TOWN OF LAKEVILLE MEETING POSTING & AGENDA

**RE: 2 Bedford Street, Commercial Site Plan
Response to Comment letter dated March 16, 2022**

PROPOSED SITE DEVELOPMENT PLANS AT 2 BEDFORD STREET LAKEVILLE, MASSACHUSETTS

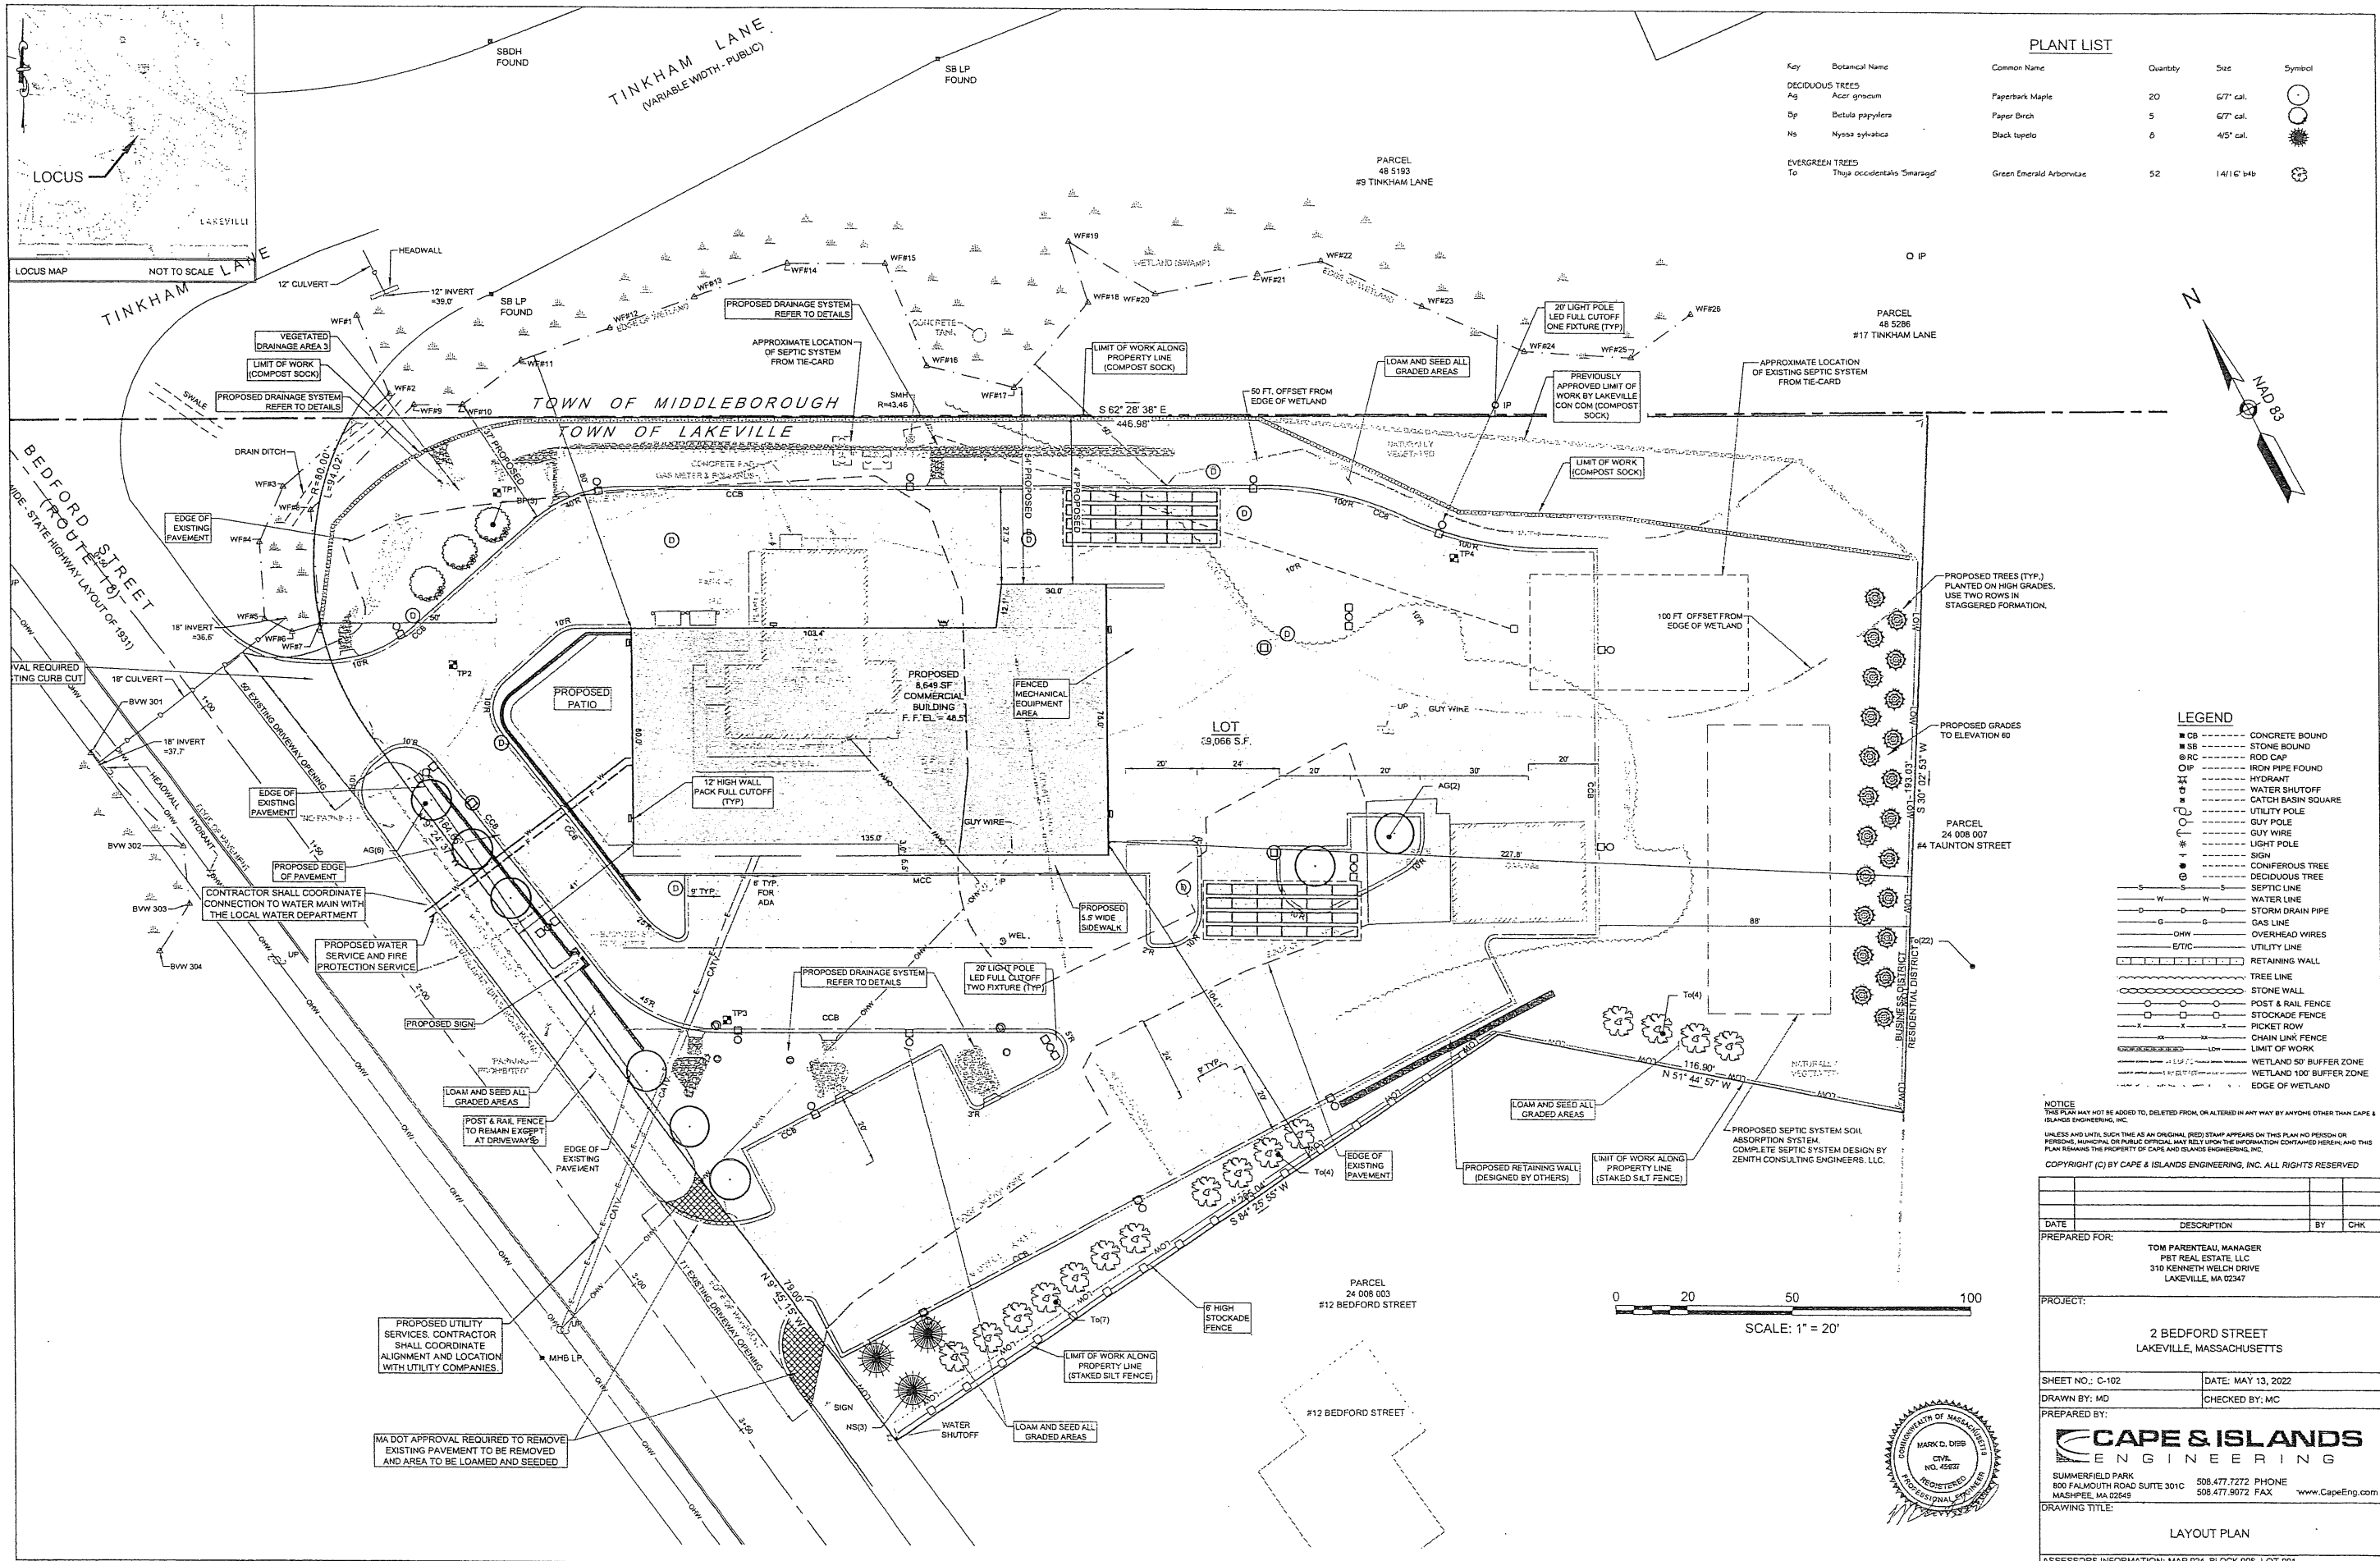
- The location of the abutting houses should be shown on the plan. Section 6.7.2.1 - **Added to plan.**
- The dumpster location is not convenient for restaurant personnel and would be better located along the North side of the site by the rear retaining wall. - **Revised dumpster location**

- Section 5.2.3 of the Zoning By-Laws requires a 40' buffer at the rear of the property. A 3 0' buffer is shown - **revised**
- Location of mechanical equipment should be shown. - **Added to plan**

- There is a drive thru shown on the building plans but there is a proposed patio between the street and the building. If a drive thru is proposed the site plan needs to be modified, if not these windows and signage should be removed from the building drawings. - **Drive thru removed**

- The first two spaces on either side of the southern parking lot and the first one in the other front lot should be removed as any cars waiting for these spots could be waiting in the roadway which could create a dangerous situation given the speeds of Bedford street. - **The spaces have been removed.**

- Additional landscaping should be added along the front of the site and the south side near the street - **Landscaping added to layout plan.**
- A 6-foot-high solid wood or vinyl fence should be placed along the property line with #12 Bedford Street where the abutting houses are at the back of the lot. - **6' high solid fence added along the property line with lot #12**

- There are no areas identified as loading or unloading areas. - **Loading area added.**
- There is a difference in the number of restaurant seats shown in the parking requirement chart. It shows both 80 and 78 seats - **Parking lot reconfigured and parking requirements updated.**

DRAWING TITLE:
GRADING, DRAINAGE AND UTILITY PLAN

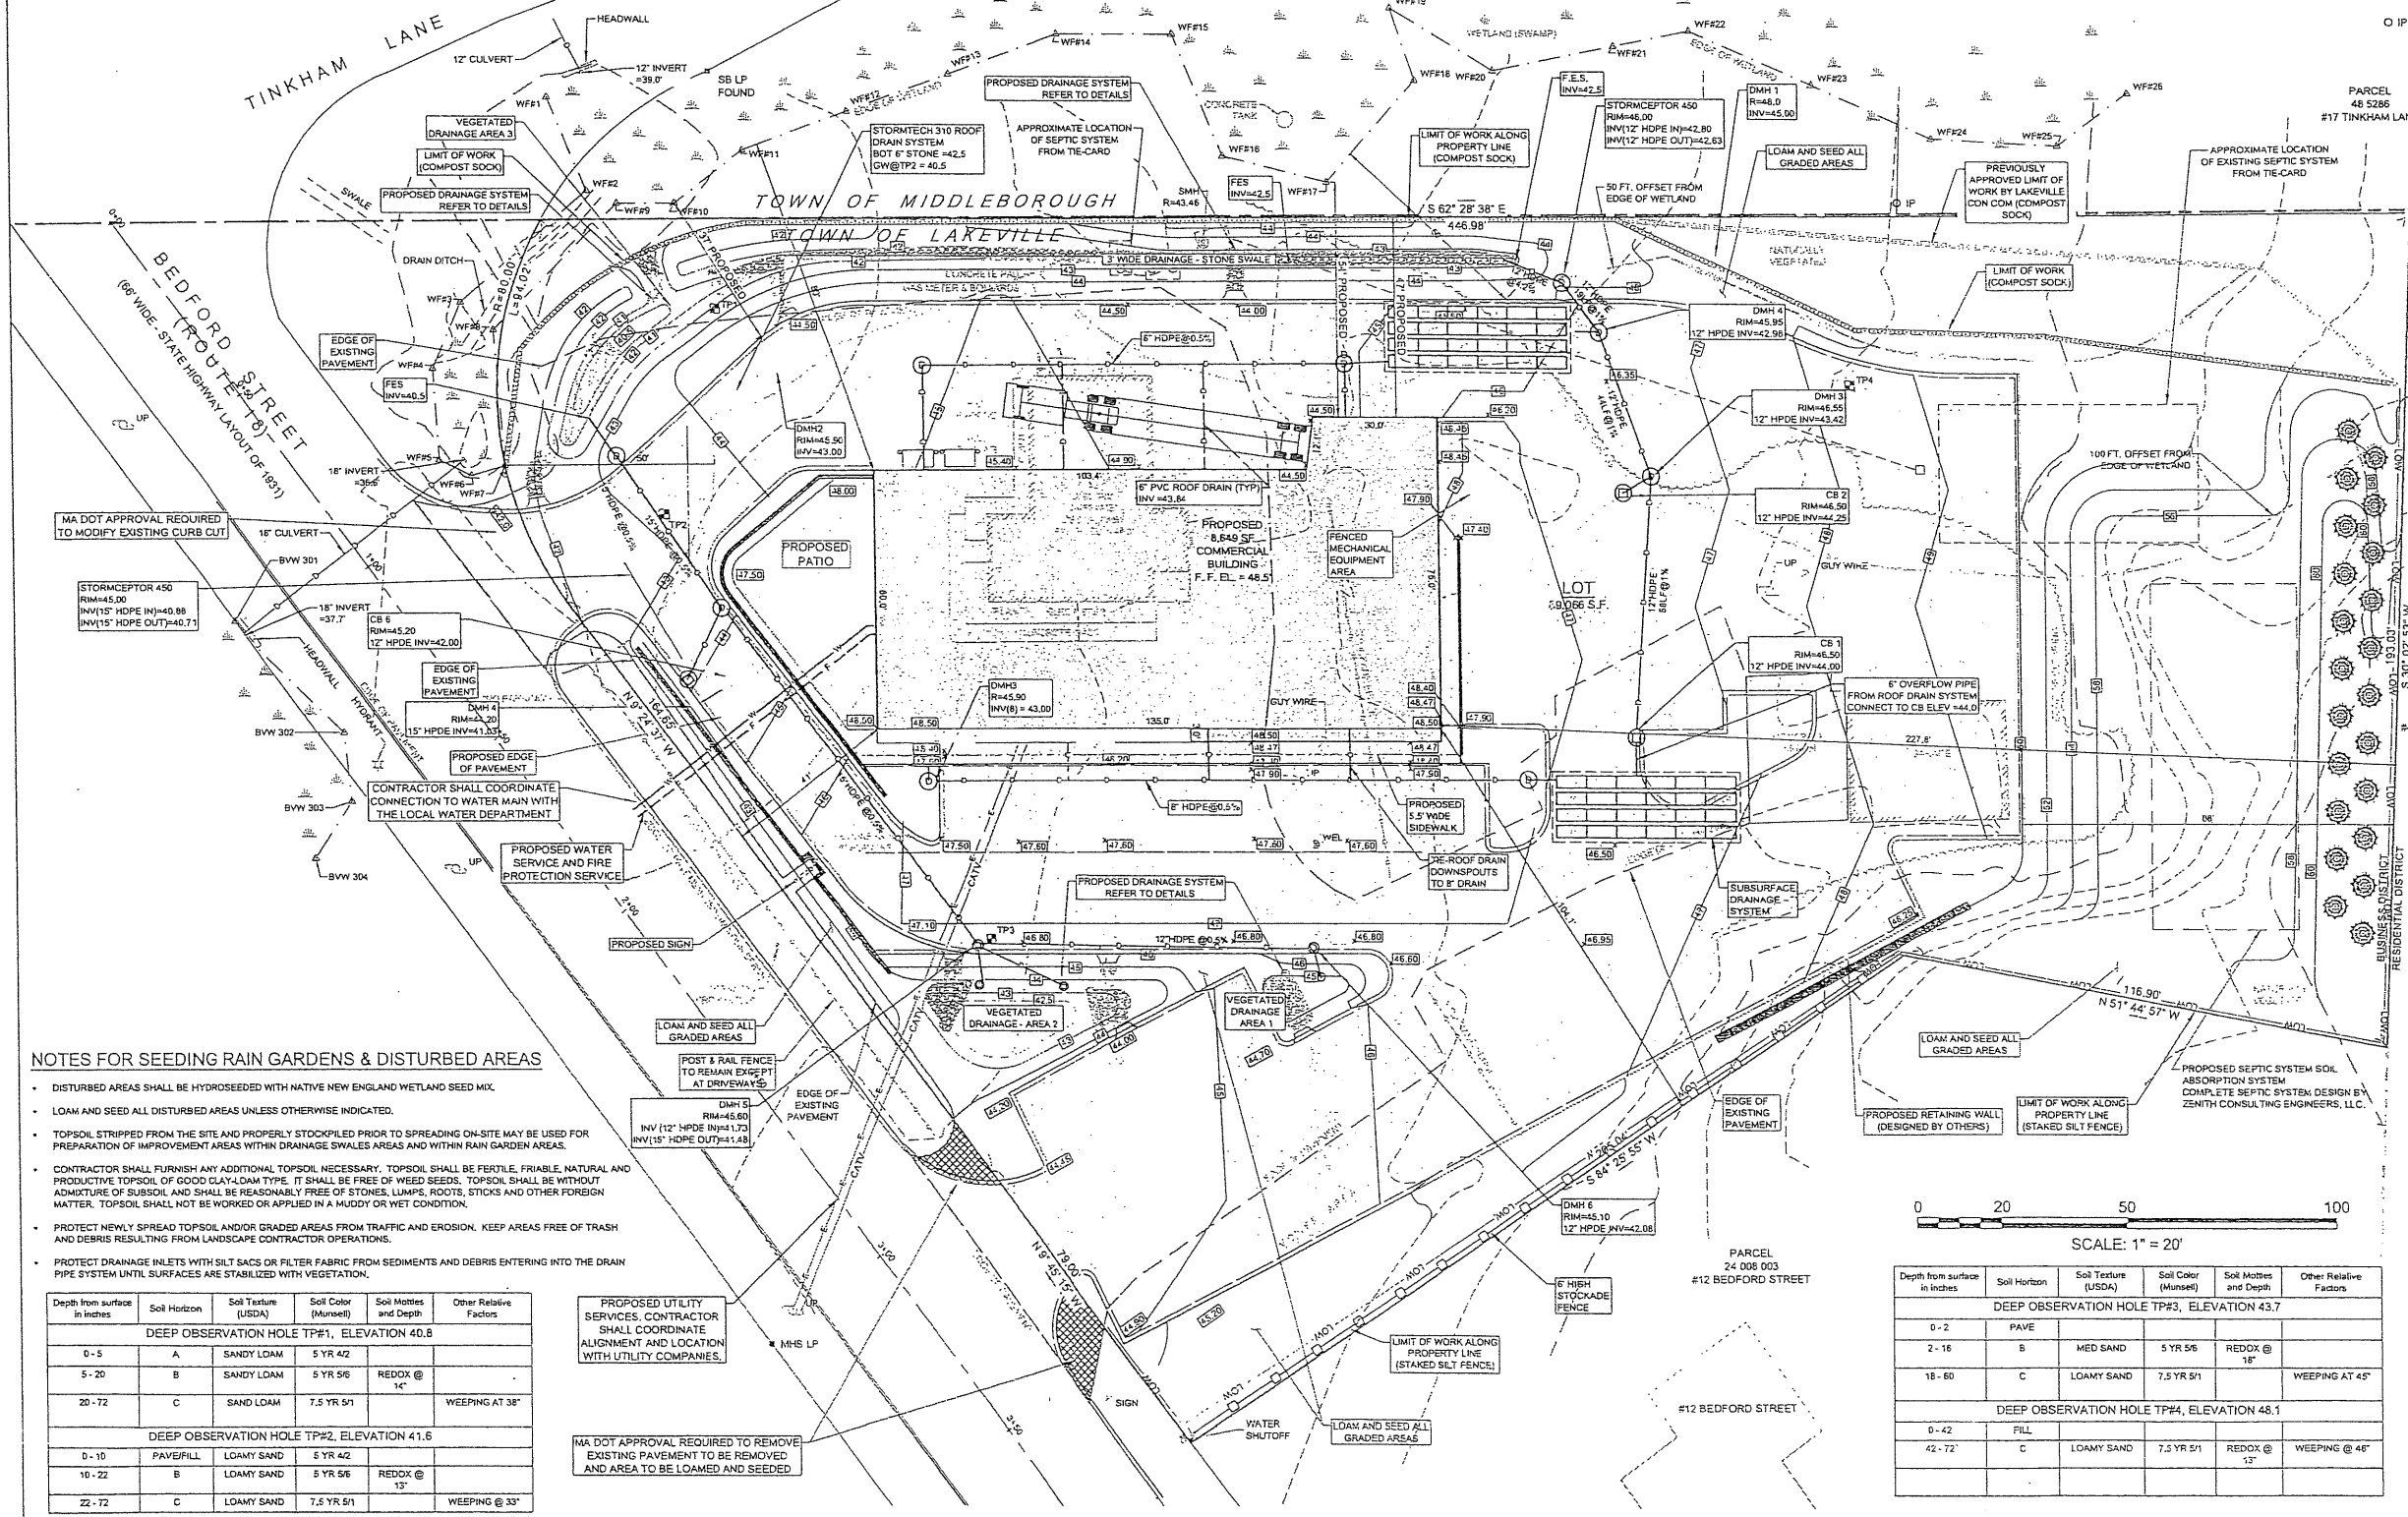
The Board of Health would like the existing well to be properly Abandoned and Decommissioned according to Massachusetts DEP guidelines, for a Public Water Source. The Board of Health does not have any objections, to the plan, providing the well is properly Abandoned and Decommissioned.

DRAWING TITLE:
PHOTOMETRIC PLAN
ASSESSORS INFORMATION: MAP 024, BLOCK 008, LOT 001

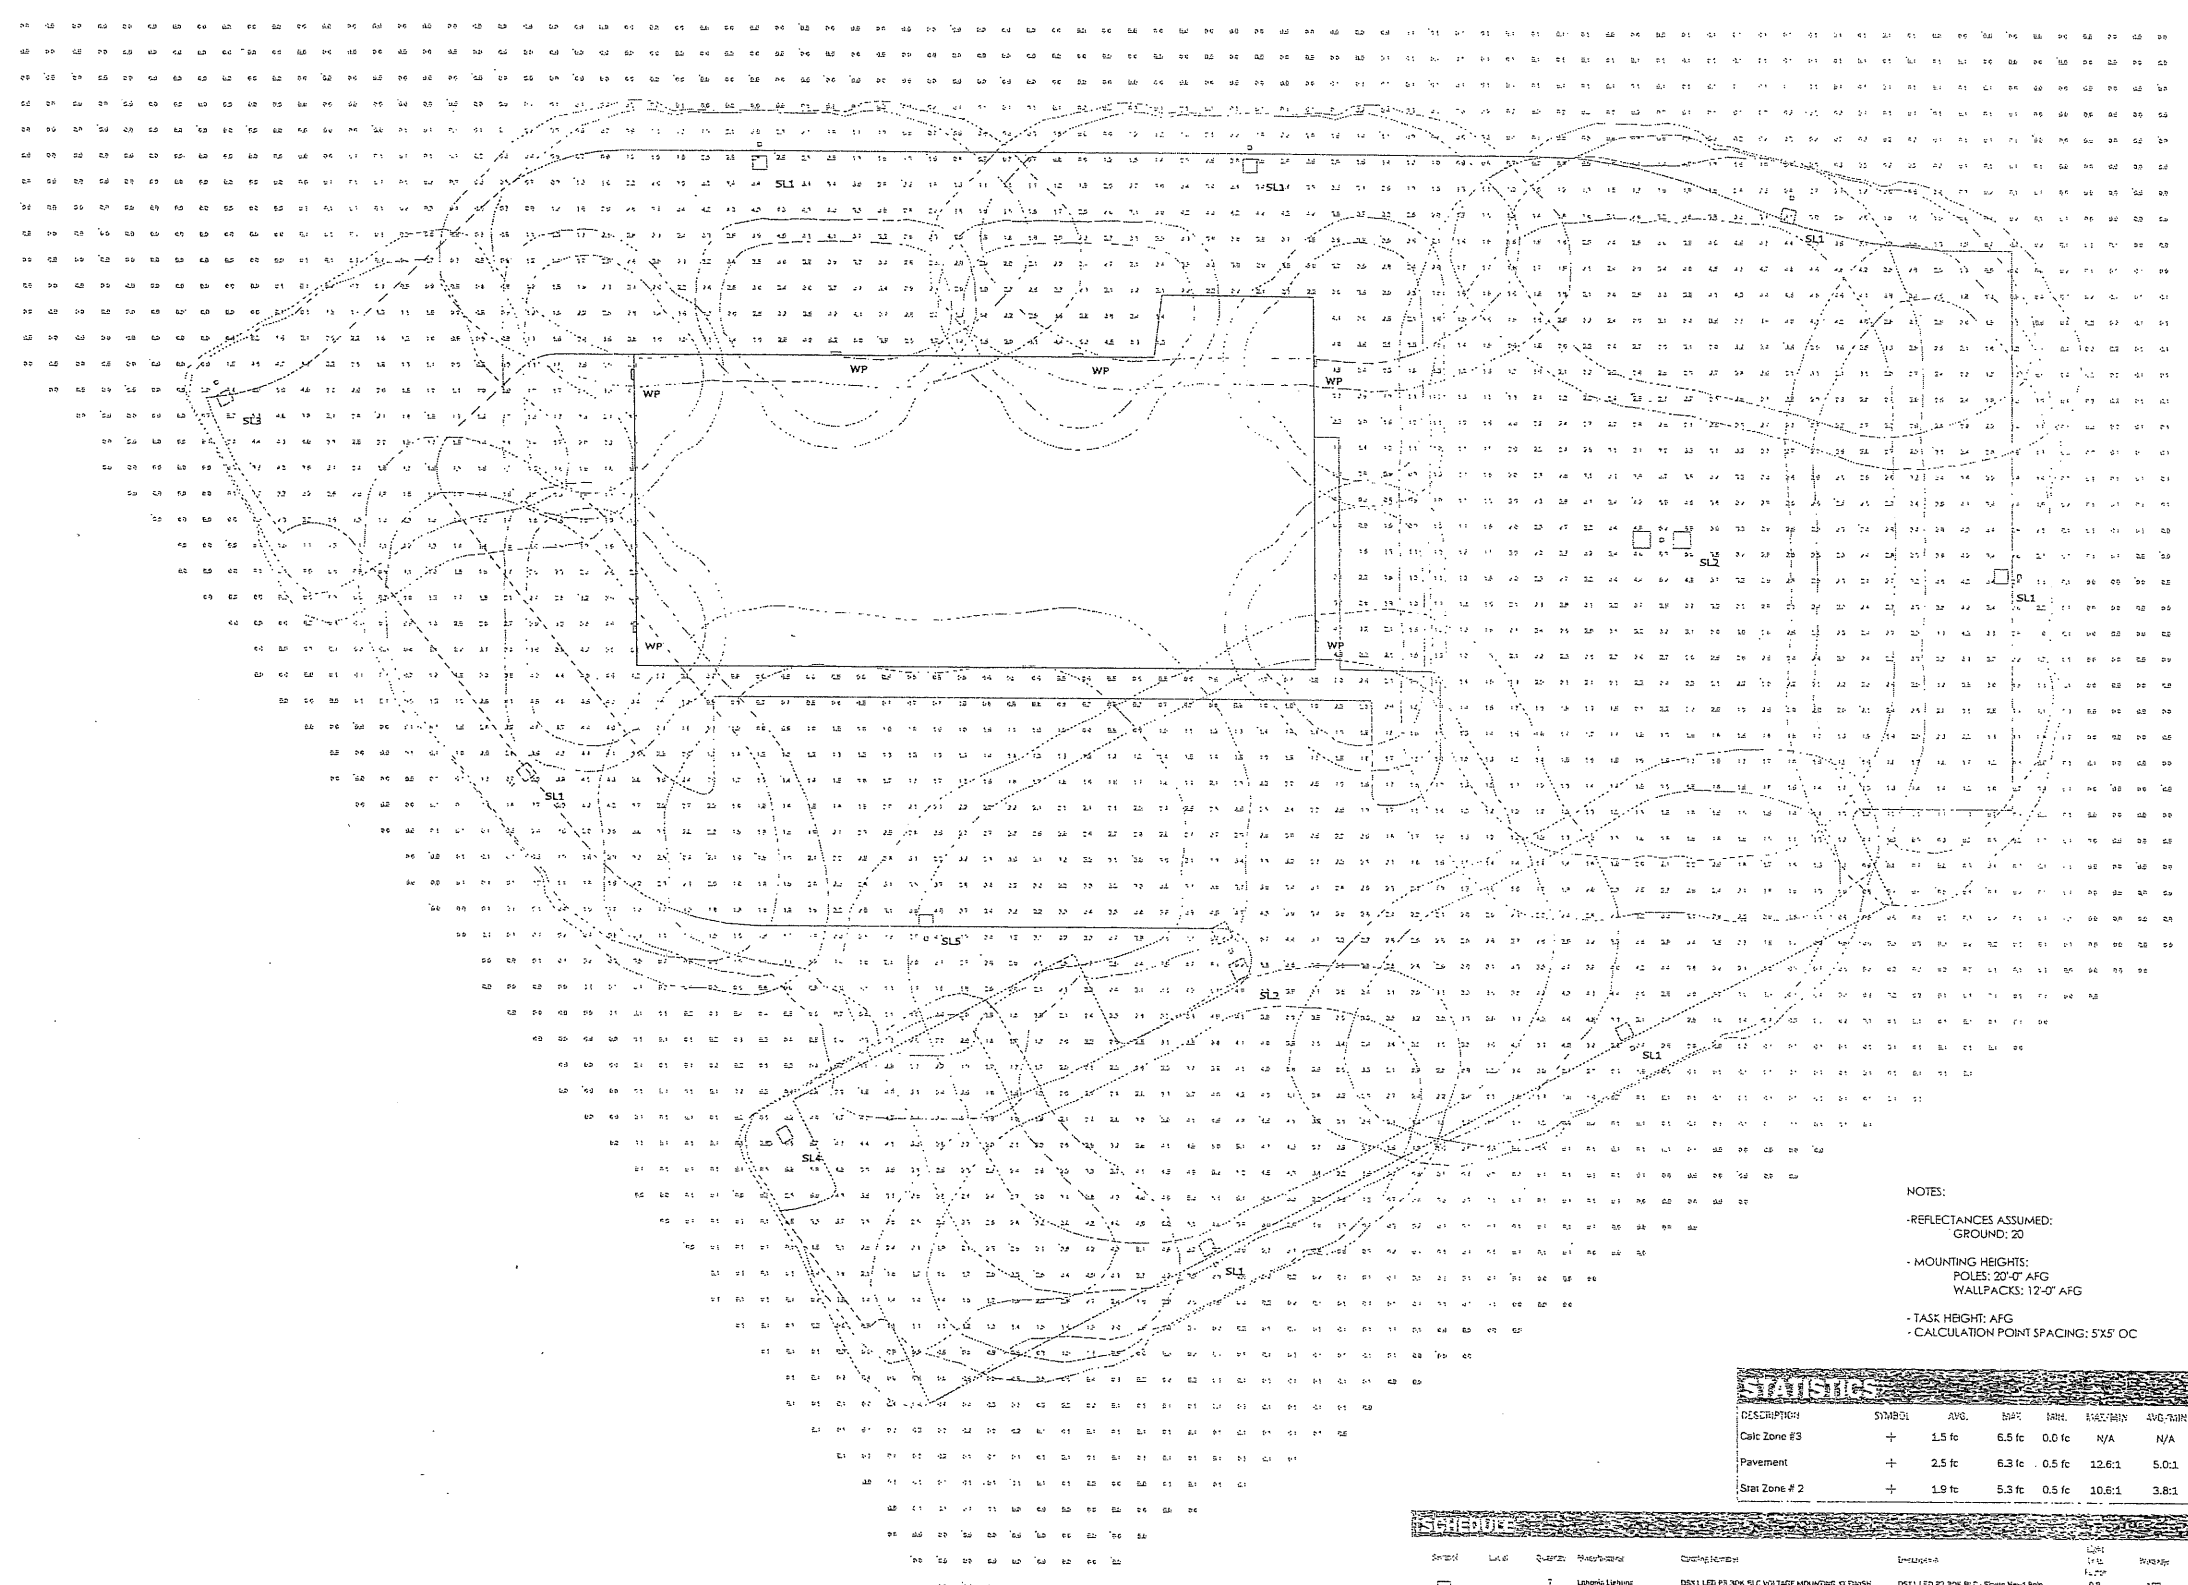
- A lighting plan should be submitted as well as details of all exterior lighting fixtures. These should be dark sky compliant and comply with Lakeville's Outdoor Lighting By-Law. - **Dark Sky compliant LED lighting photometric plan added.**
